Landmarks Preservation Commission Planning and Development Services Department

Date: August 23, 2023
Time: 5:30 p.m.
Location: Hybrid (see below)

7. DESIGN REVIEW

AGENDA ITEM 7A: 824 N. M St. (North Slope Historic District)

NEW NORTH EXTERIOR ELEVATION

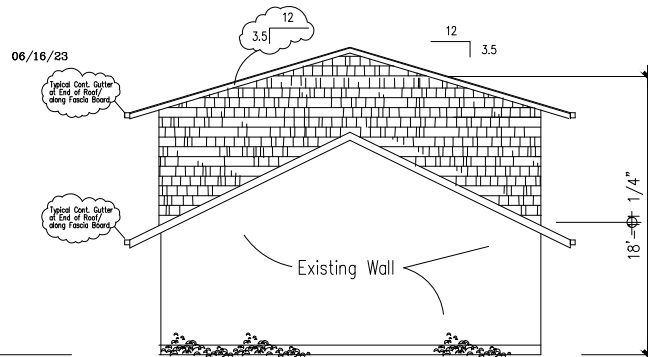
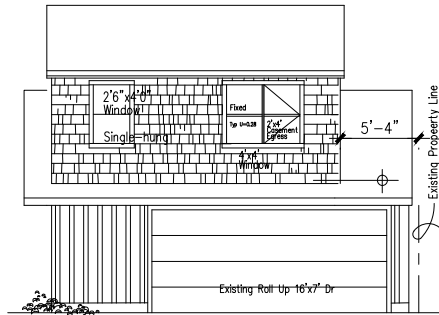
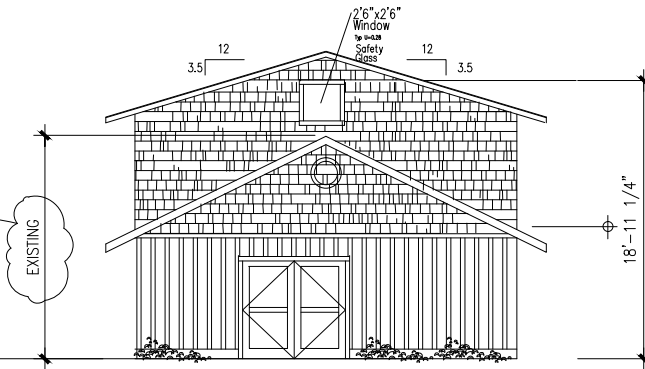
4. The creation of a DADU above the existing garage appear to meet the design guidelines, specifically Accessory Structures, #5 and #6.
5. The use of wood shingle or smooth Hardie shingle siding to match existing cladding on the garage appears to meet the design guidelines, specifically New Construction – Exterior Materials, #5.

6. The use of wood casement and hung sash windows in the DADU appear to meet the design guidelines, specifically New Construction – Windows, #3 and #4.

7. The proposed new DADU roof pitch of 3.5:12 does not appear to meet the design guidelines, specifically New Construction – Roofs, #1.
